**STRUCTURAL REPAIRS
WILLIAMS BRICE STADIUM
UNIVERSITY OF SOUTH CAROLINA
PROJECT NO: CP00420508**

**Addendum One
June 10, 2015**

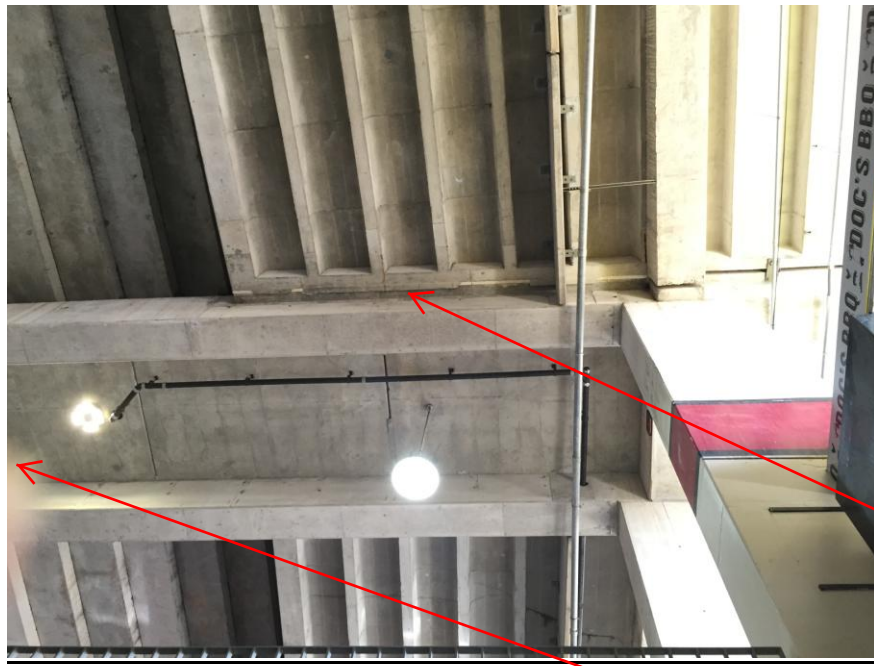
8. Sheet A206, Photos 1a & 1b / Keynote #1: Add the repair of eight additional similar conditions to this scope of work for the second ramp run up above this one.
9. West Ground Level, North ramp up to west stands: Additional Scope - Provide overhead concrete repairs to the three areas shown below:

AREA ABOUT 3' LONG WHERE REBAR IS EXPOSED. OVERHEAD REPAIR.

AREA ABOUT 15' LONG. REMOVE ORIGINAL CONCRETE OVER POUR FROM UNDER FOAM BLOCKING.

AREA ABOUT 5' LONG WHERE CONCRETE IS SPALLING. OVERHEAD REPAIR
